Amendments to the Drawings:

REMARKS/ARGUMENTS**1. Request for Continued Examination:**

4. Rejection of claims 1, 3, 4, 10, and 11 under 35 U.S.C. 102(e) and 35 U.S.C. 103(a):

Fig. 1

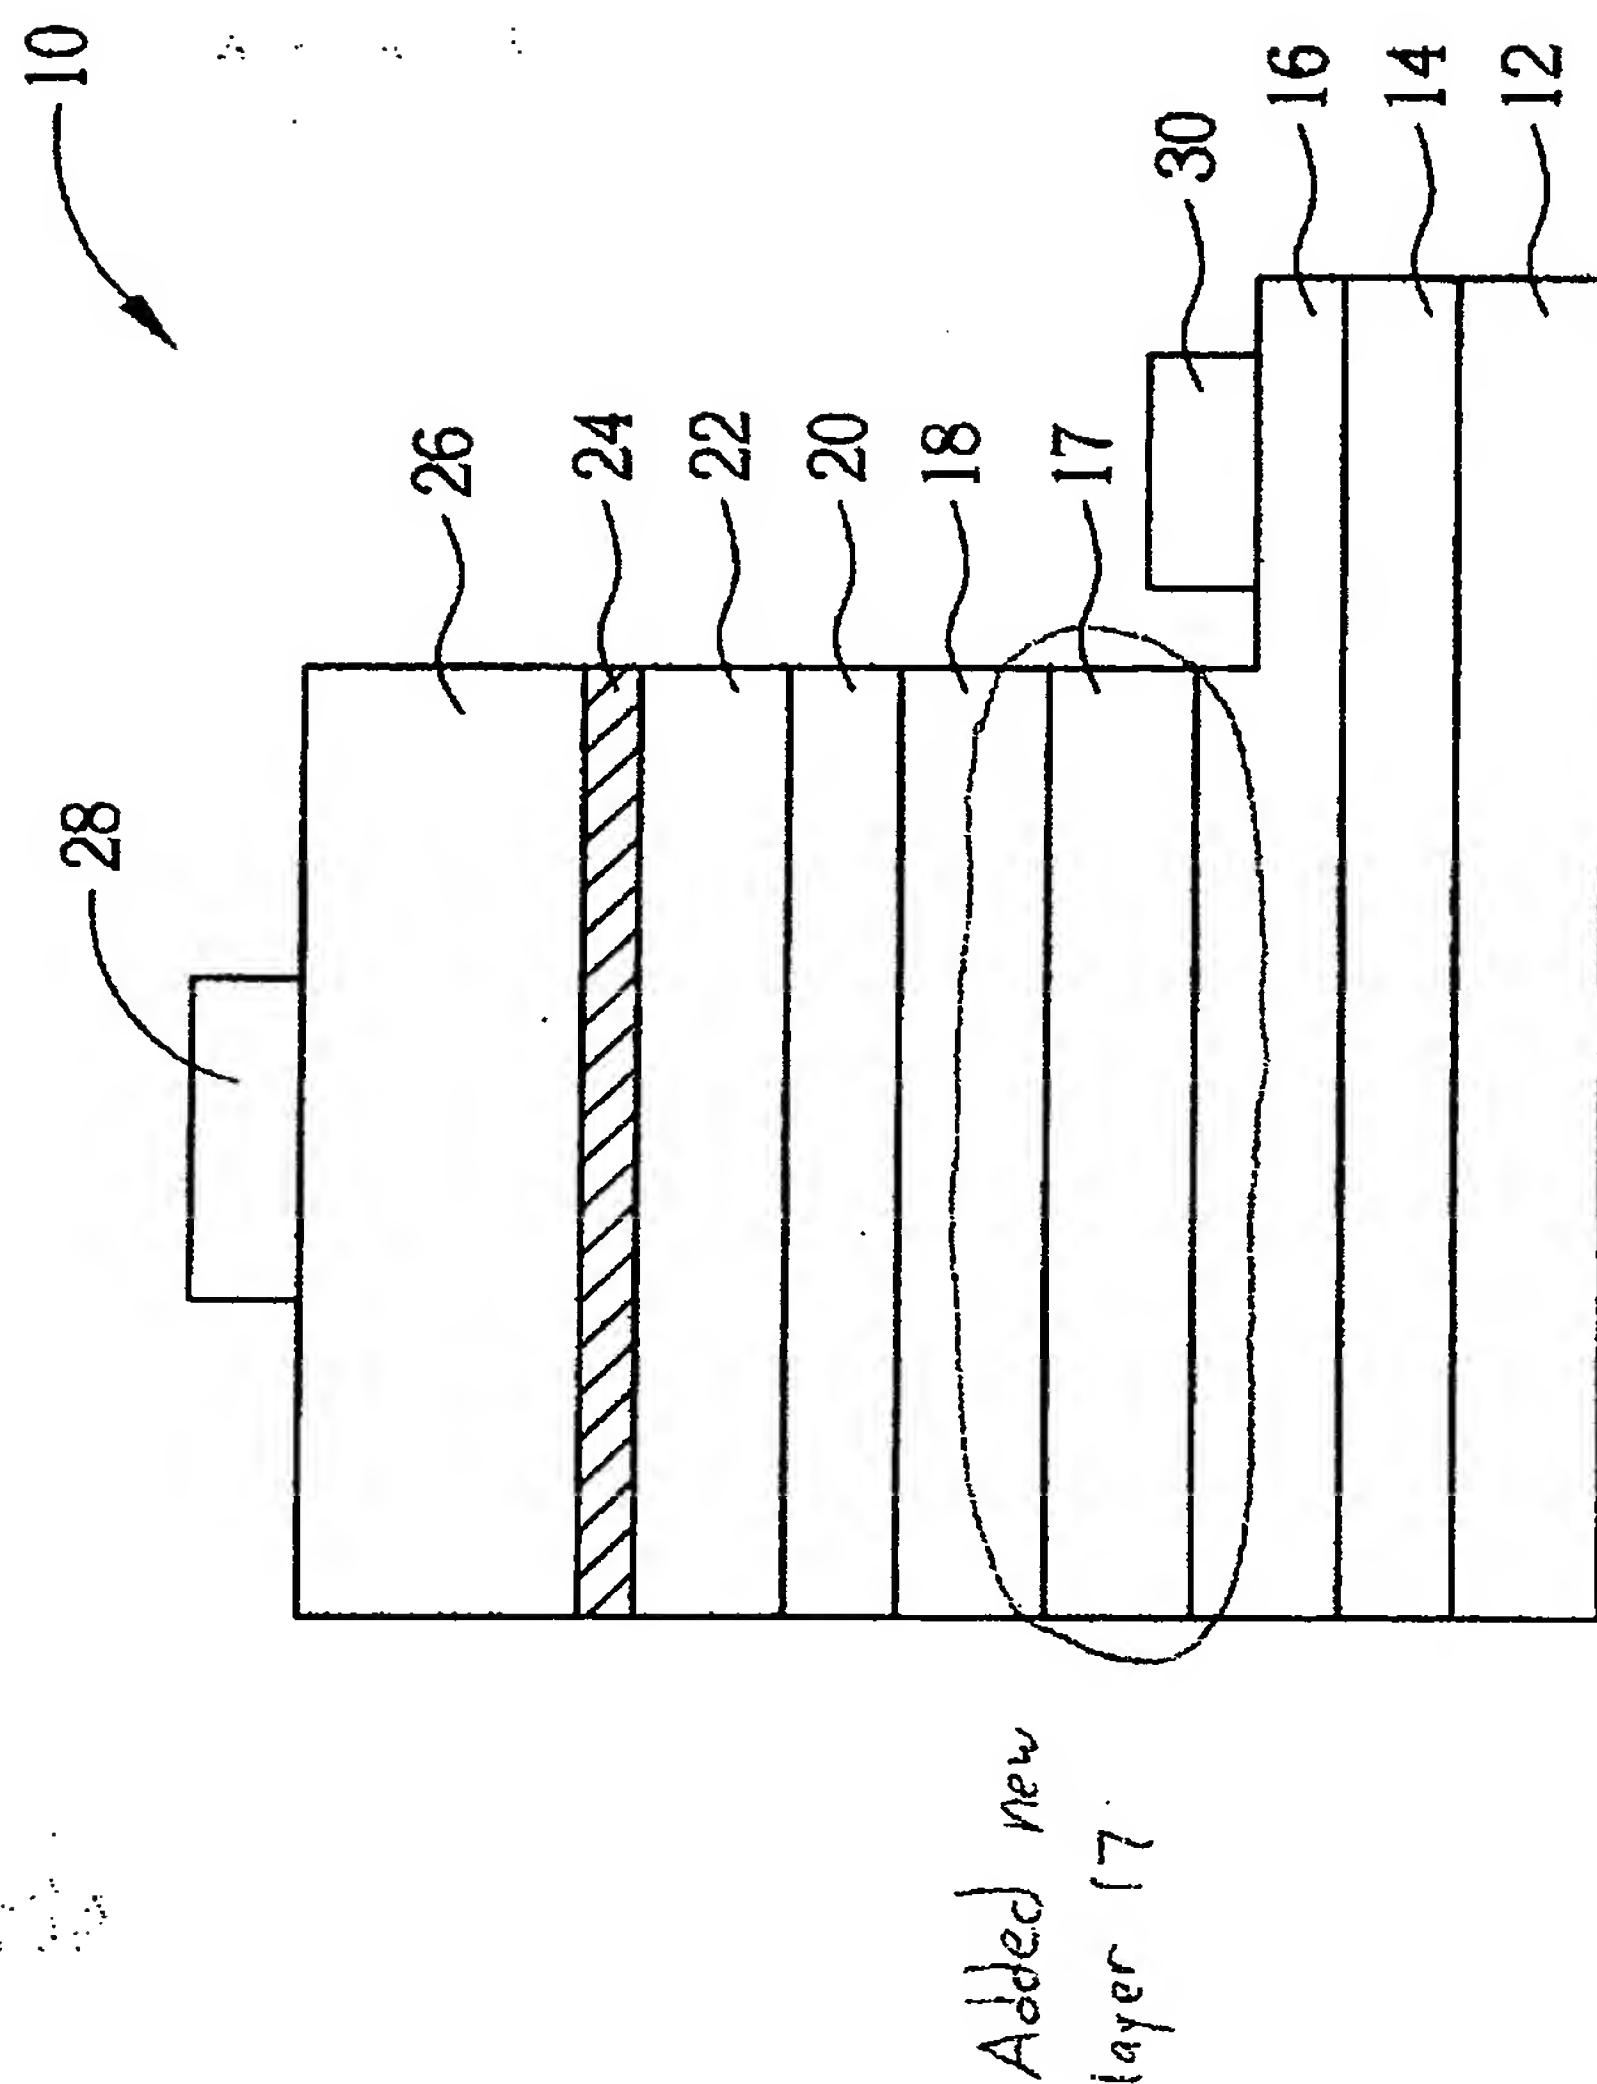
Figure 1 has been amended to show the first conductivity type cladding layer recited in claim 8. As supported in the original claim 8, the first conductivity type cladding layer 17 is interposed between the first conductivity type contact layer 16 and the multiple 5 quantum well light emitting layer 18. No new matter has been added through this amendment to Figure 1. Acceptance of the amended figure is respectfully requested.

10 Claim 8 is objected to under 37 C.F.R. 1.75(d) because "the first conductivity type cladding layer" of claim 8 has not been disclosed in the remainder of the specification nor illustrated in any of the drawings. Appropriate correction is required.

As noted above, Fig.1 has been amended to illustrate the first conductivity type cladding layer.
